City of Ketchum

Recommendation to hold a public hearing, consider public input, and approve the Onyx at Leadville Residence Lot Line Shift

IN RE:)	
)	
The Onyx at Leadville Residence)	KETCHUM CITY COUNCIL
Lot Line Shift)	FINDINGS OF FACT, CONCLUSIONS OF LAW, AND
Date: December 7, 2020)	DECISION
)	
File Number: P20-052)

REQUEST: Lot Line Shift to reconfigure and reassign parking spaces within the common area garage

A CONDOMINIUM PLAT SHOWING THE ONYX AT LEADVILLE RESIDENCE

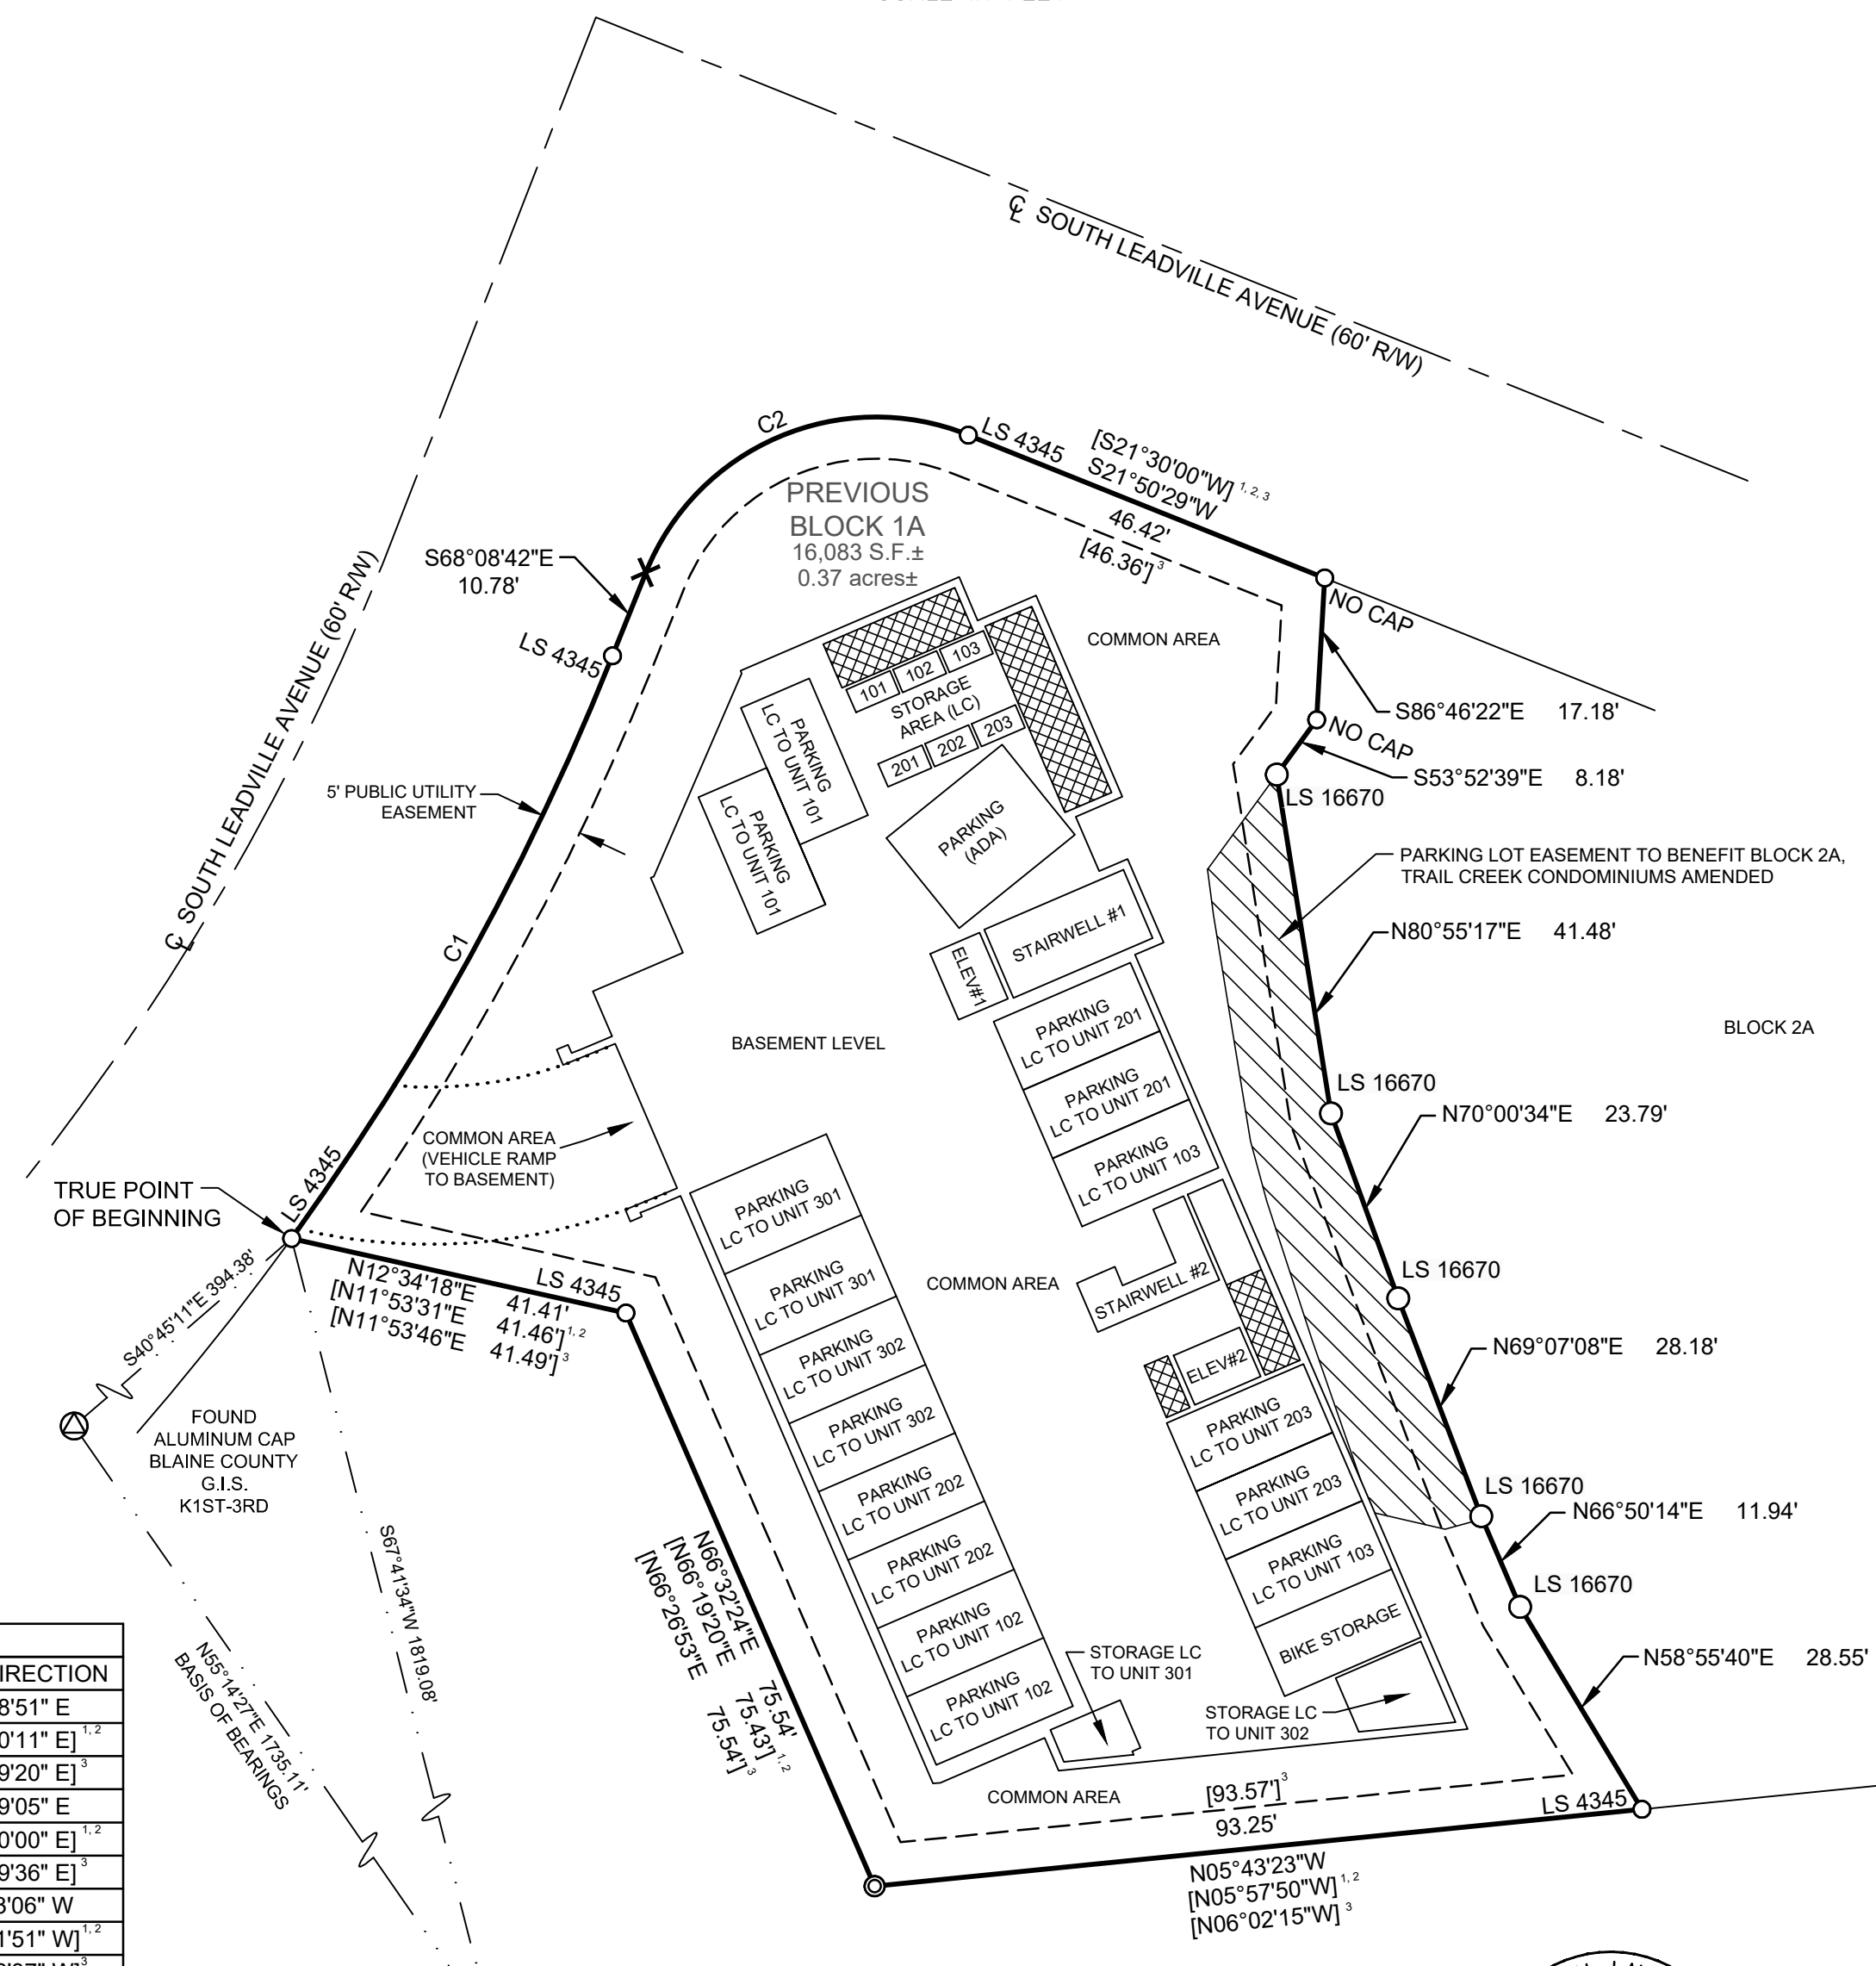
<input checked="" type="checkbox"/>	<input type="checkbox"/>	<input type="checkbox"/>	<p>16.04.030.K.4</p> <p>Names and locations of all adjoining subdivisions.</p> <p><i>Staff Comments</i> The adjacent Trail Creek Crossing Condominiums has been noted on the plat.</p>
<input checked="" type="checkbox"/>	<input type="checkbox"/>	<input type="checkbox"/>	<p>16.04.030.K.5</p> <p>Name and right of way width of each street and other public rights of way.</p> <p><i>Staff Comments</i> This standard has been met.</p>
<input checked="" type="checkbox"/>	<input type="checkbox"/>	<input type="checkbox"/>	<p>16.04.030.K.6</p> <p>Location, dimension and purpose of all easements, public or private.</p> <p><i>Staff Comments</i> All existing easements are indicated. This Lot Line Shift action does not include the creation of any new easements.</p>
<input type="checkbox"/>	<input type="checkbox"/>	<input checked="" type="checkbox"/>	<p>16.04.030.K.7</p> <p>The blocks numbered consecutively throughout each block.</p> <p><i>Staff Comments</i> N/A this is a lot line shift to reconfigure and reassign parking spaces within the parking garage.</p>

<input checked="" type="checkbox"/>	<input type="checkbox"/>	<input type="checkbox"/>	<p>16.04.030.K.10</p> <p>Scale, north arrow and date.</p> <p><i>Staff Comments</i> This standard has been met.</p>
<input checked="" type="checkbox"/>	<input type="checkbox"/>	<input type="checkbox"/>	<p>16.04.030.K.11</p> <p>Location, width, and names of all existing or dedicated streets and other public ways within or adjacent to the proposed subdivision</p>

1. The recorded plat shall show a minimum of two Blaine County Survey Control Monuments with ties to the property and an inverse between the two monuments. The Survey Control Monuments shall be clearly identified on the face of the map.
